COUNTY OF FLUVANNA, VIRGINIA
(IFB) #2021-01
FLUVANNA COUNTY – BASEMENT RENOVATION

ADDENDUM # 2:

ADDENDUM NO. 2

Fluvanna County
Multipurpose Room Additions and Renovations
CRA Project No. 3430

7 SECTION AT CRAWL SPACE ACCESS 1/2" = 1'-0"

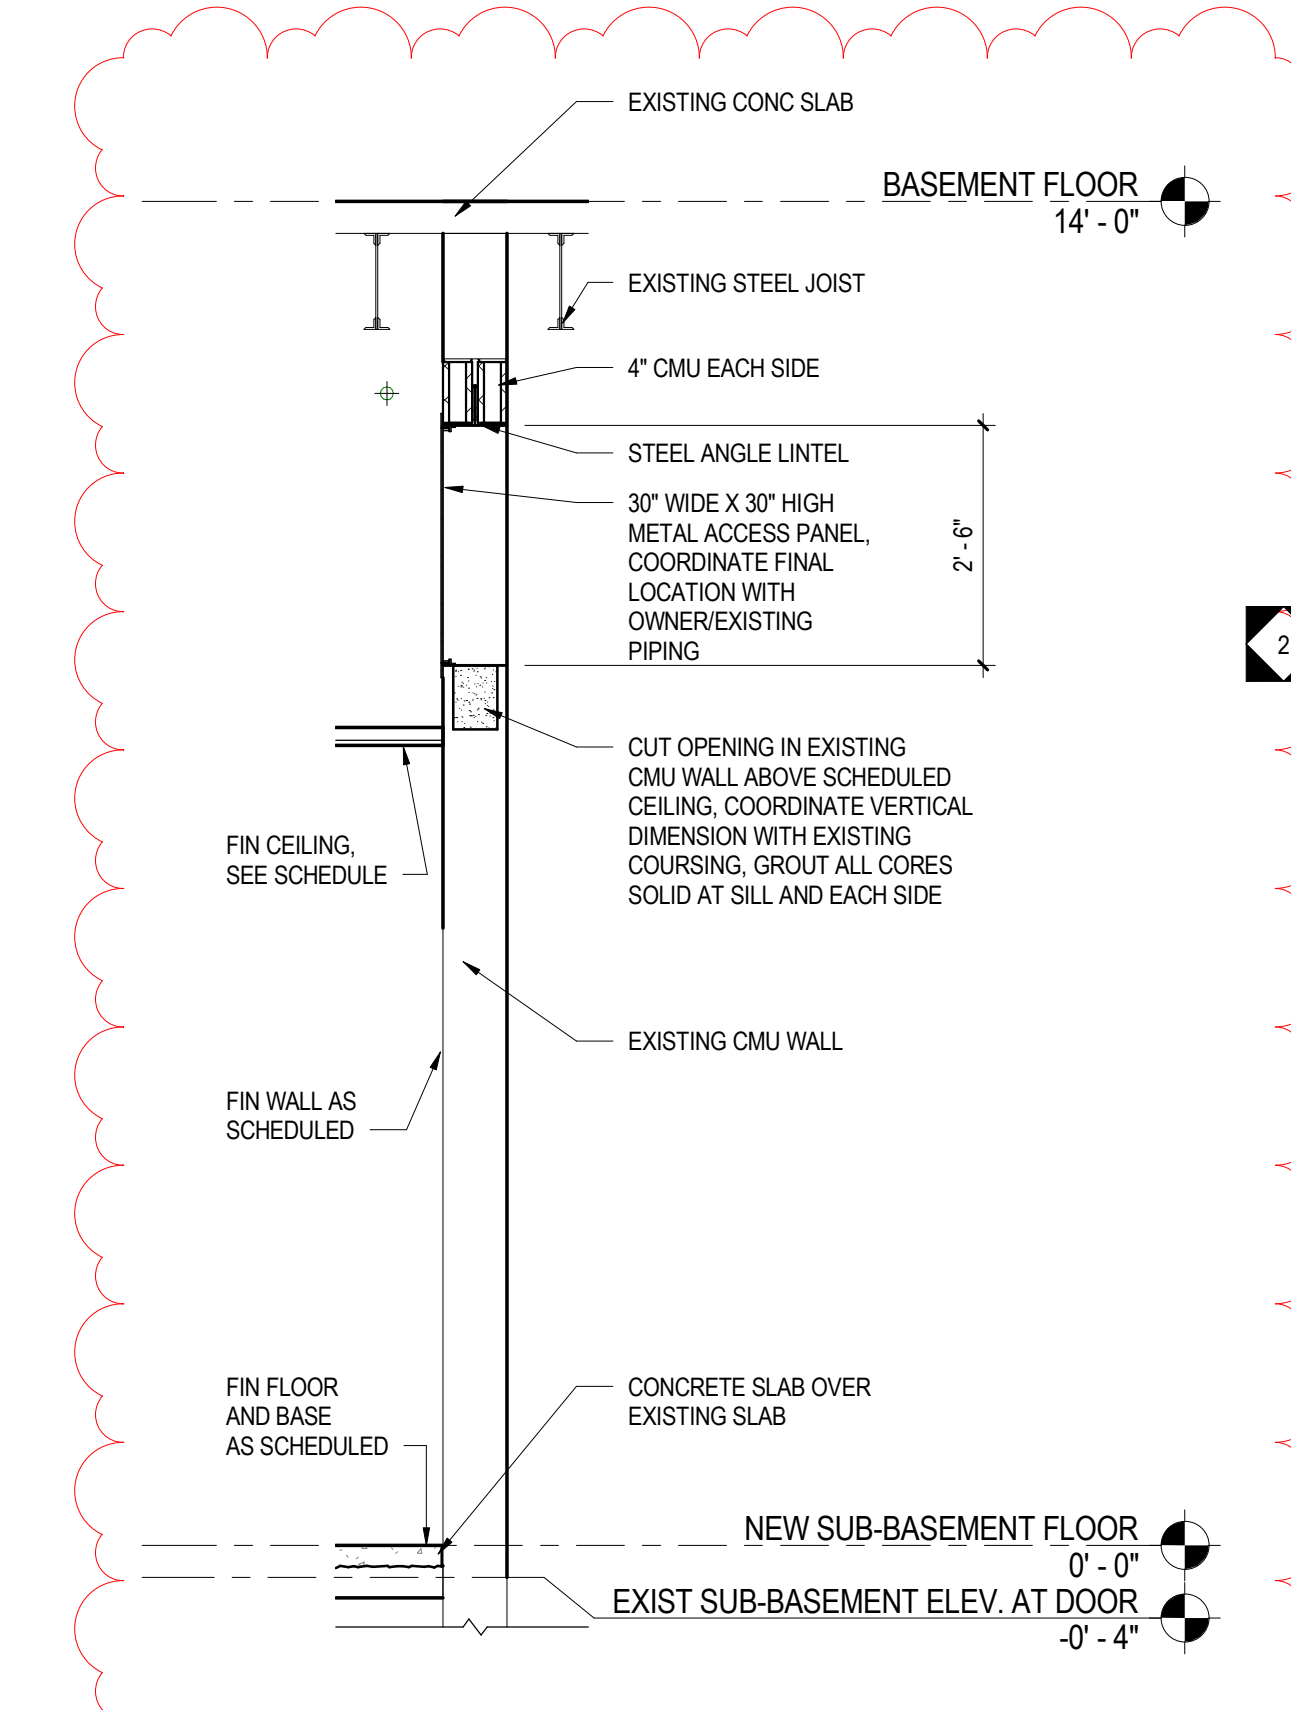
1. REPLACE this sheet in its entirety with the attached sheet.
 - a. Added wall section with access panel.

2 FIRST FLOOR AIR DISTRIBUTION NEW WORK
1/8" = 1'-0"

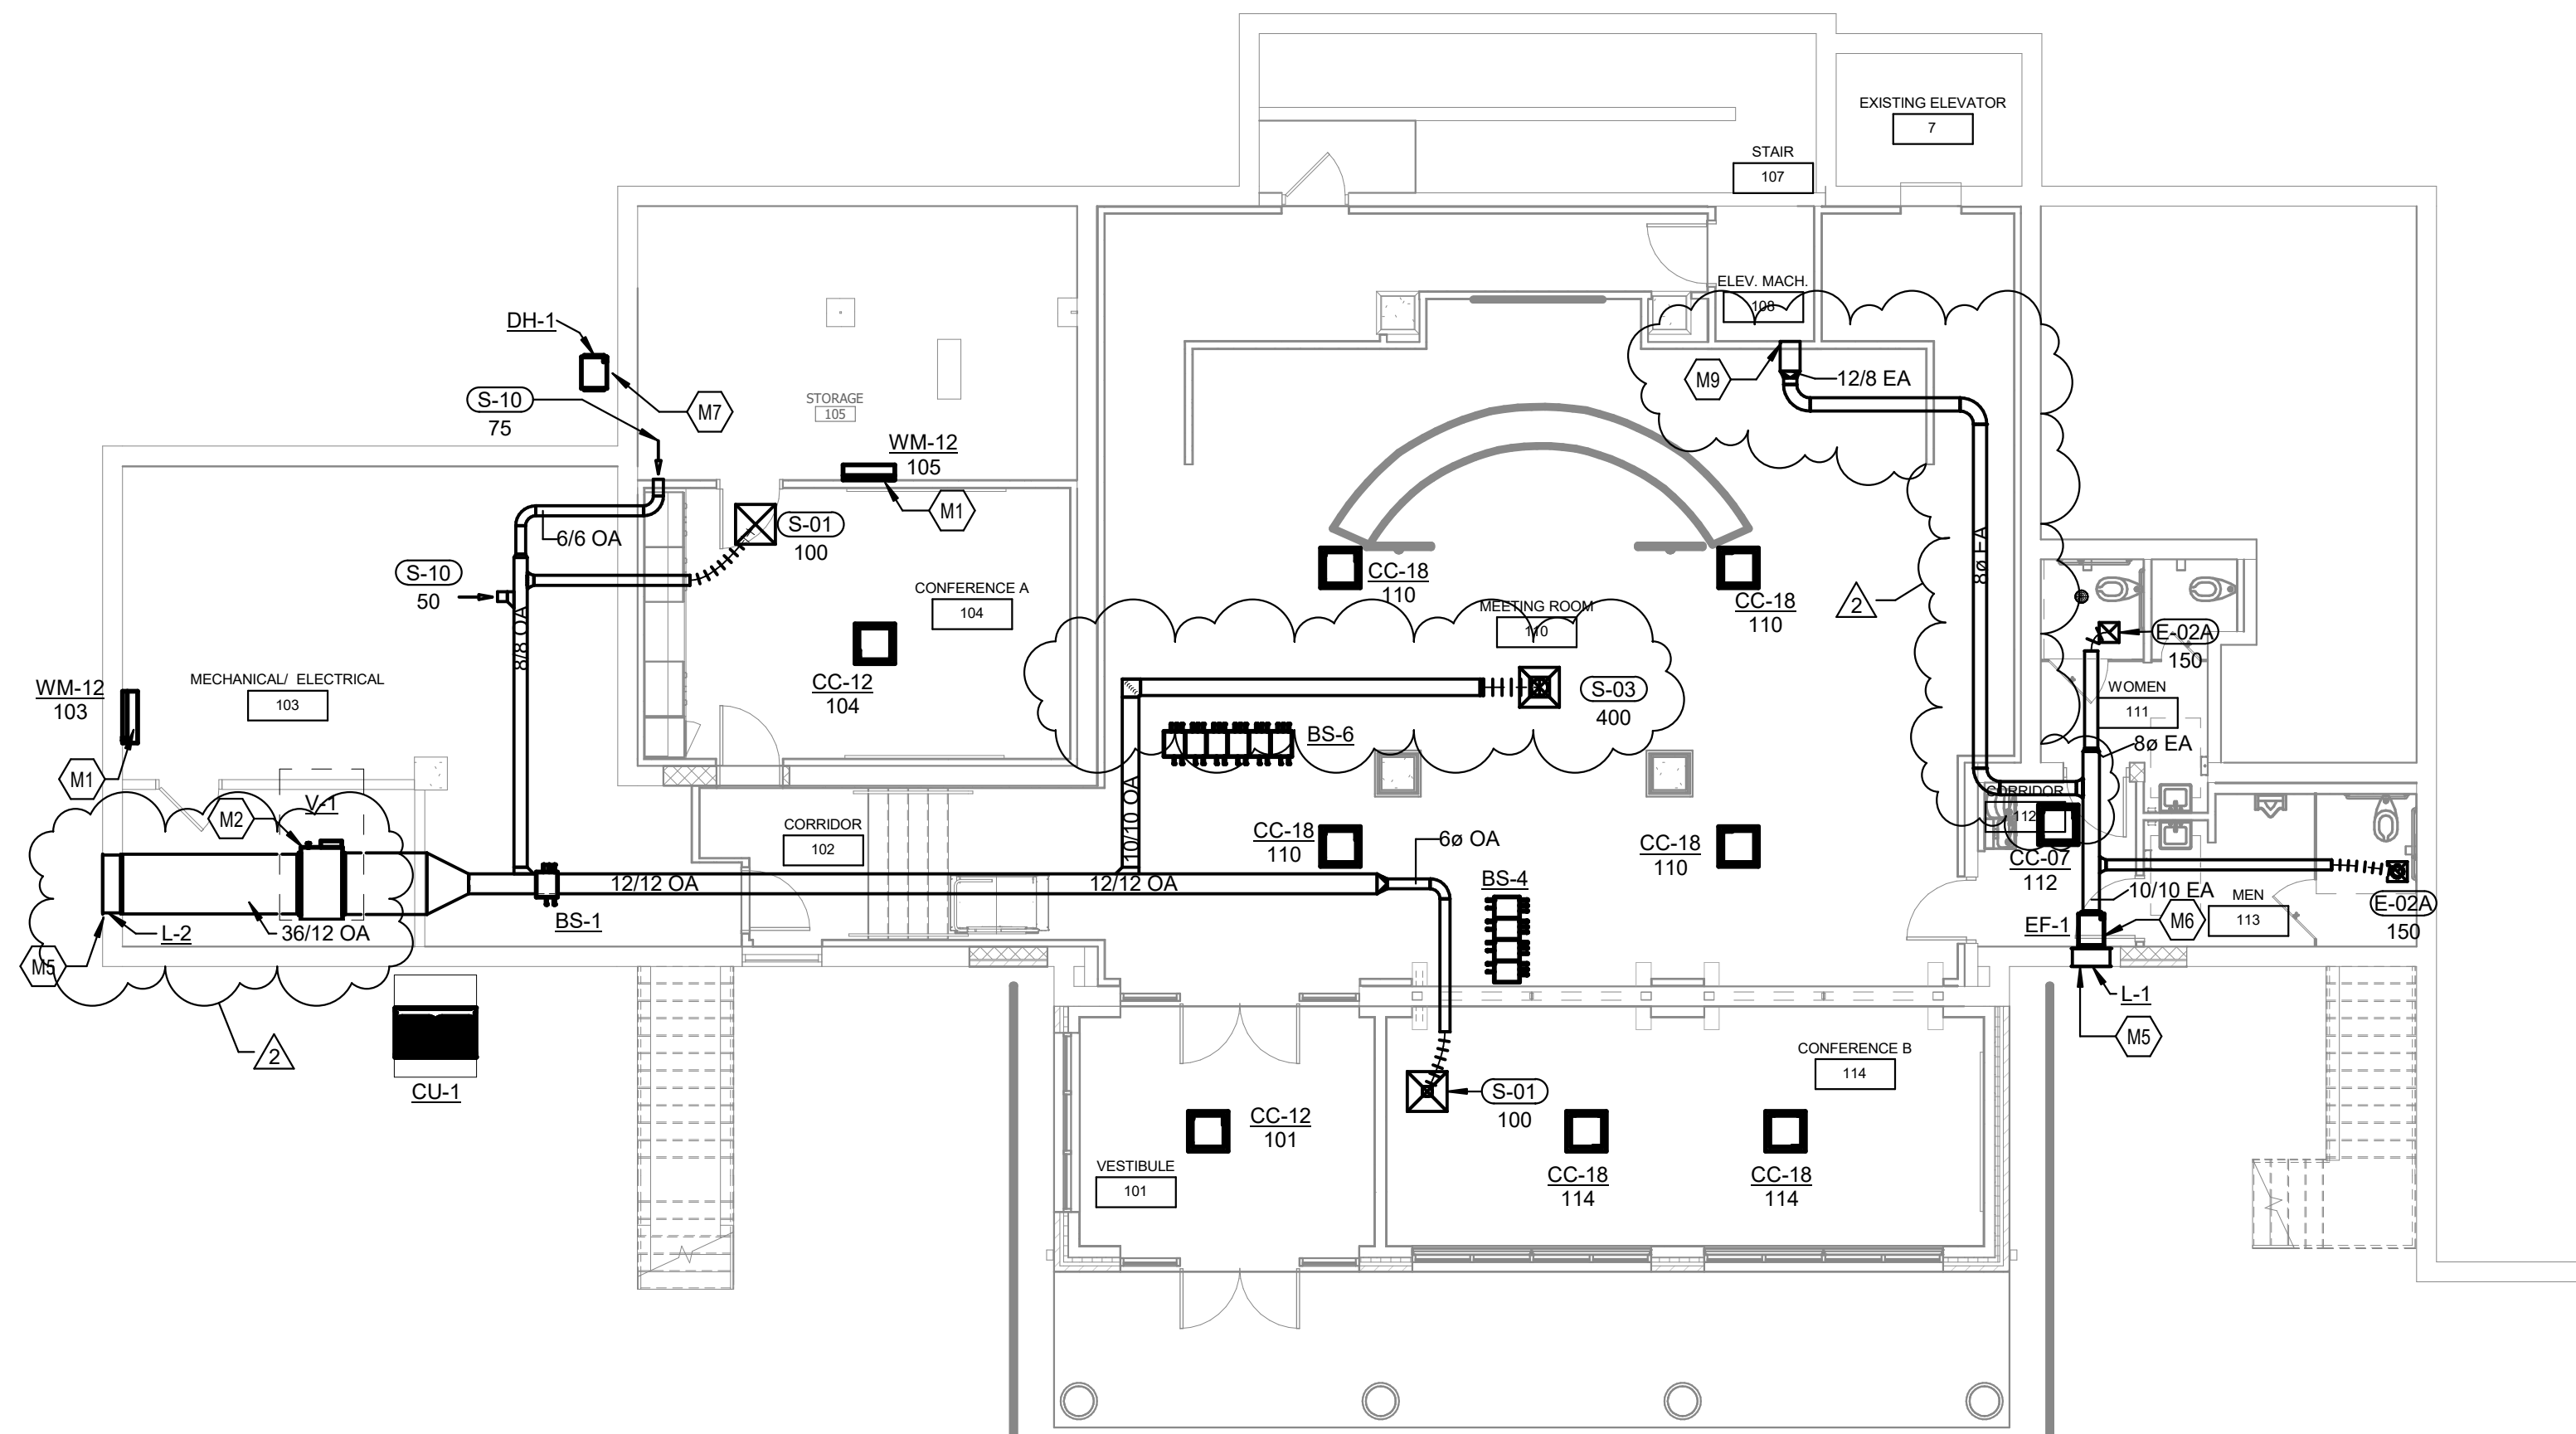
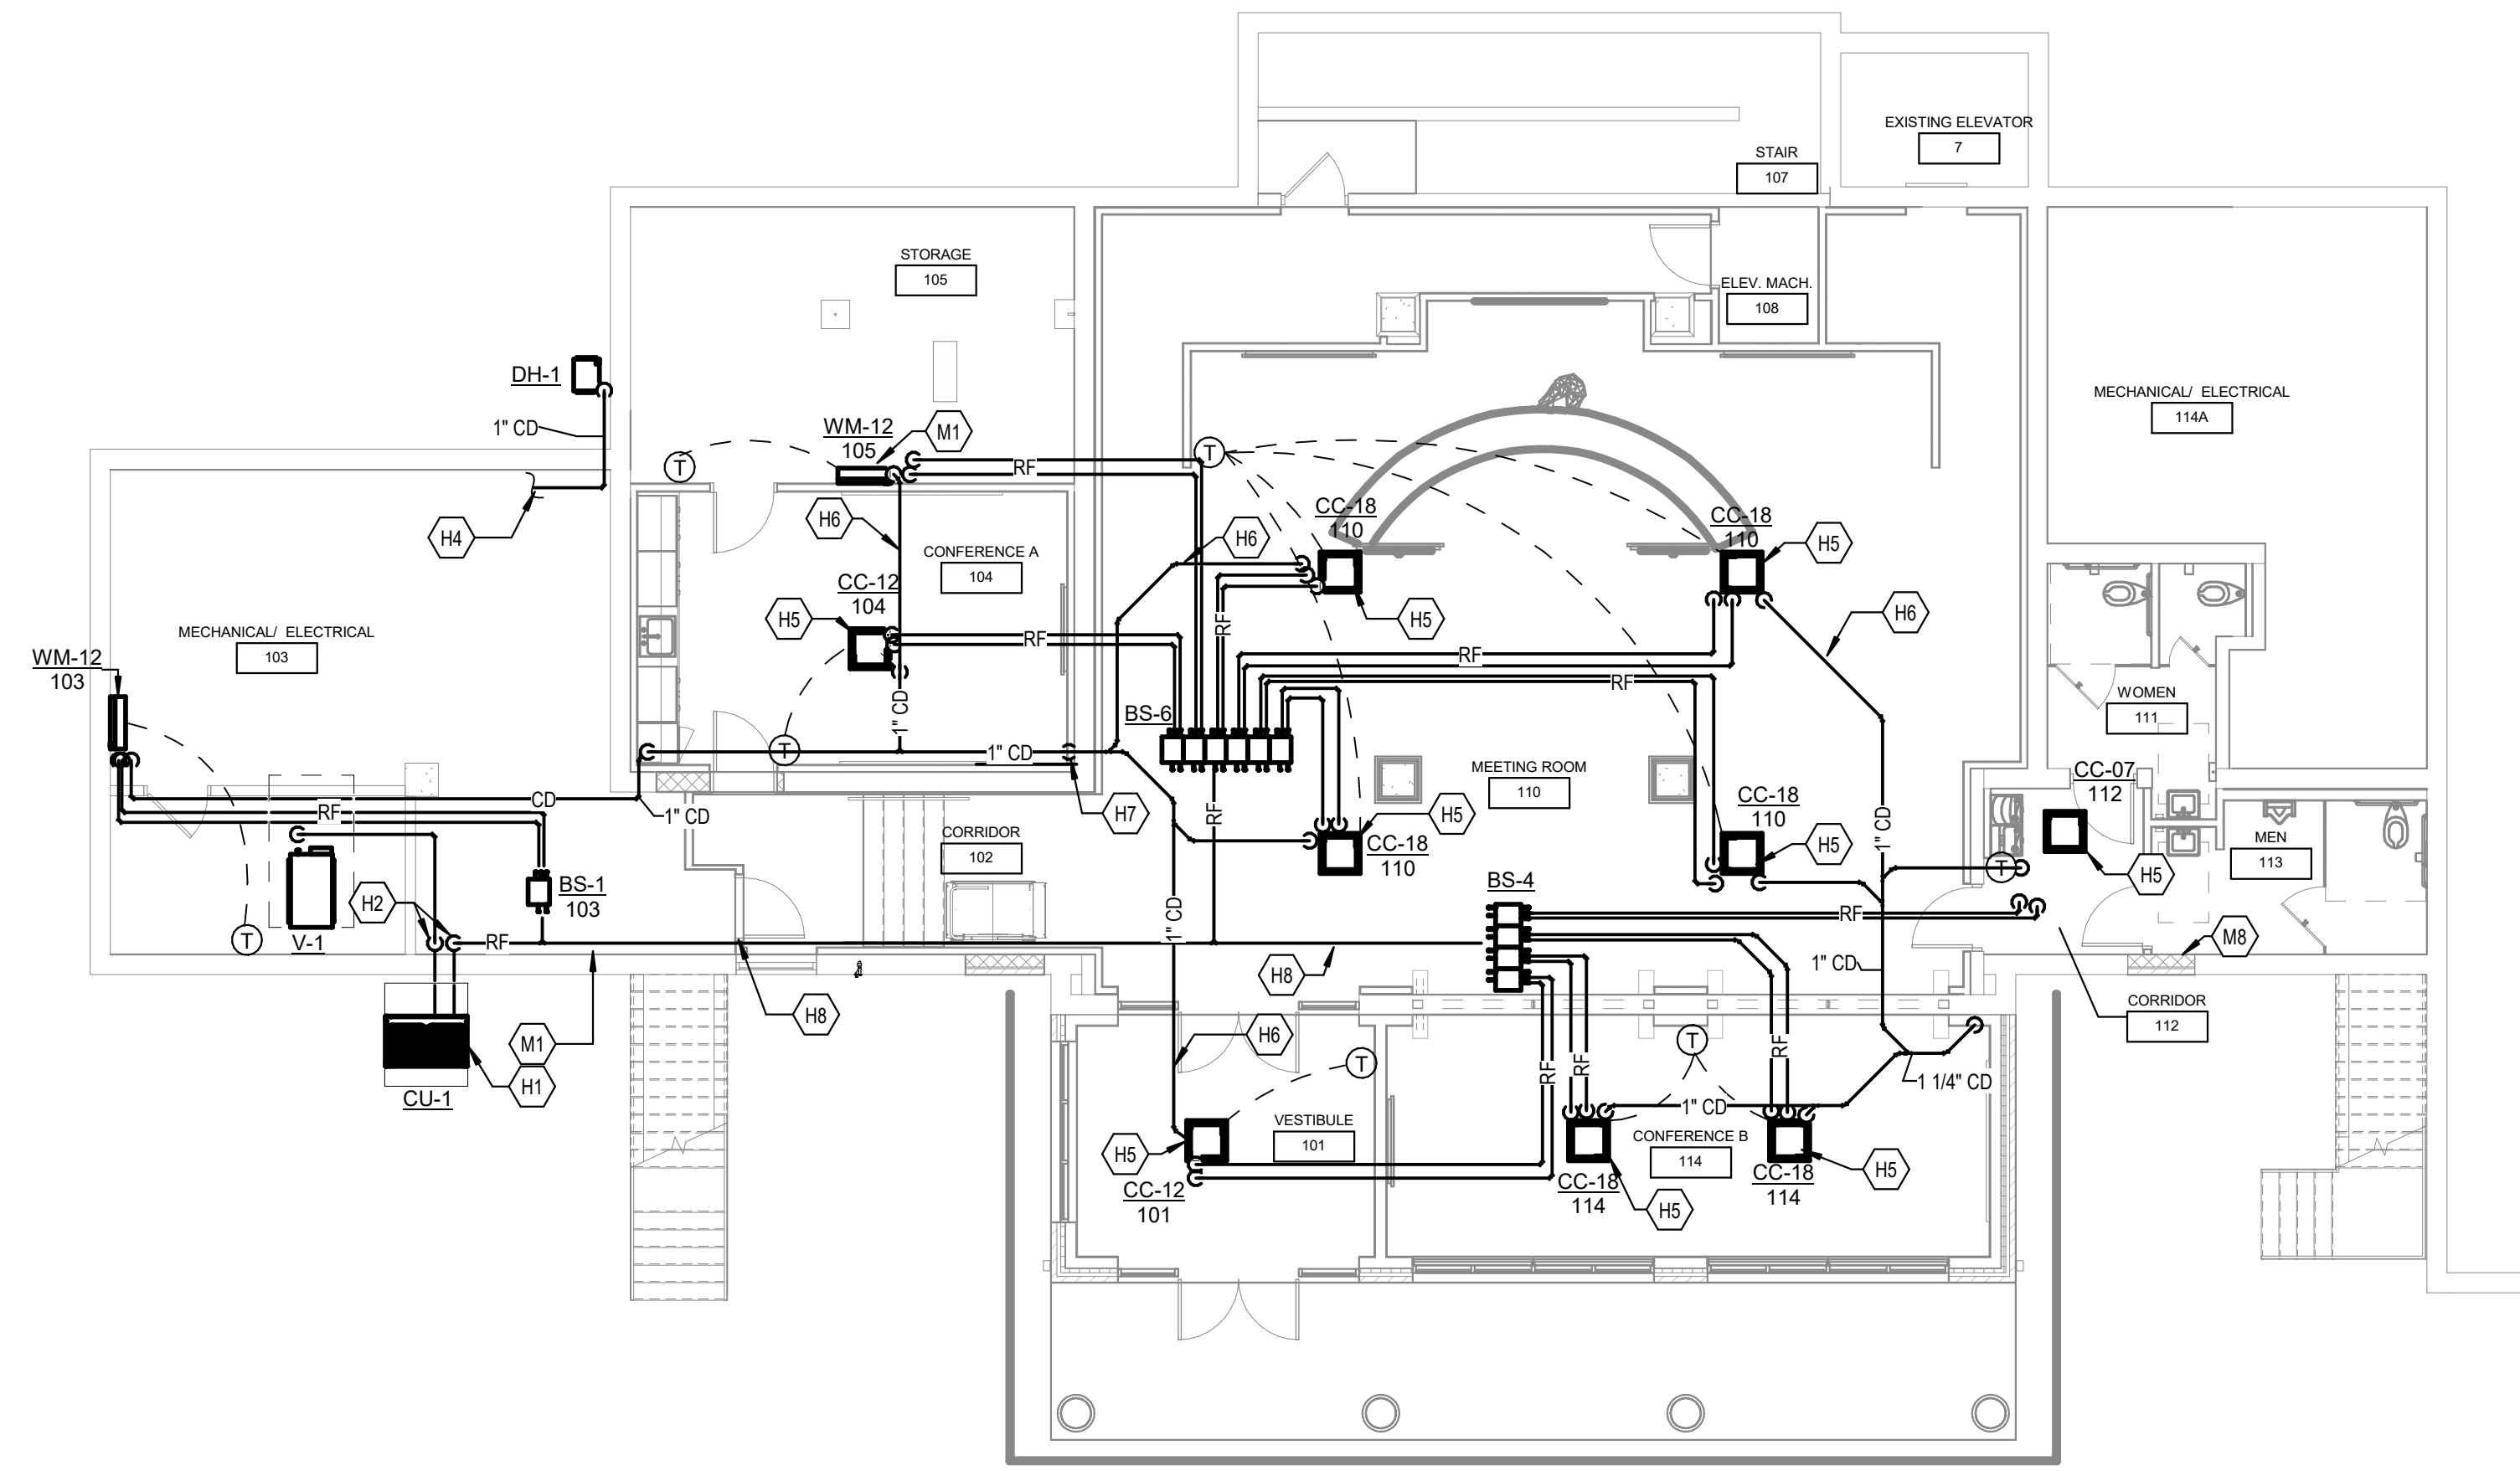
1. REPLACE this sheet in its entirety with the attached sheet.
 - a. V-1 ductwork was straightened.
 - b. Added new 8"Ø Exhaust Air to connect to existing Elevator Machine Room.
